CBD and South East Light Rail Project Environmental Impact Statement (EIS) Derek Hodgkins 74/30 Nobbs Street Surry Hills NSW 2010

I am writing to you to give you my feedback regarding the CBD and South East Light Rail Environmental Impact Statement (EIS).

Typical tree on north side of Devonshire street with stunted growth due to proximity of overhead wires and severe pruning by electrical companies

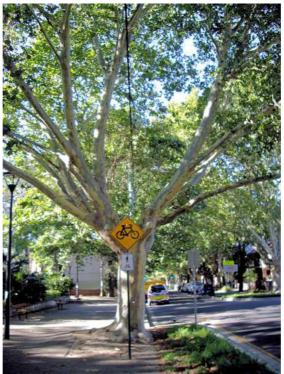
I would like to point out that from Holt Street up to Riley St, the northern side of Devonshire street has overhead electrical cabling which crosses the road near Ward Park and continues down the south side of Devonshire Street to Bourke Street. This is not shown on the 'artists impression' pictures that have been distributed showing the area near the Shakespeare Hotel and Ward Park<sup>3</sup>.

As a consequence of the electricity companies regularly and severely pruning trees near overhead electrical cabling, all of the trees on the north side of Devonshire Street are weird shapes or have difficulty growing to a height much above 3 to 4 meters.

Replacing the mature large-canopy trees near Northcott Estate with trees on the northern side of Devonshire Street will therefore be ineffective in restoring the ambiance of Devonshire Street unless these cables are placed below ground.

The EIS talks about the 'undergrounding of electricity supply along Devonshire Street'<sup>4</sup>. I hope that this includes all the overhead cables in the street so that the replacement trees have the capability to mature unhindered.
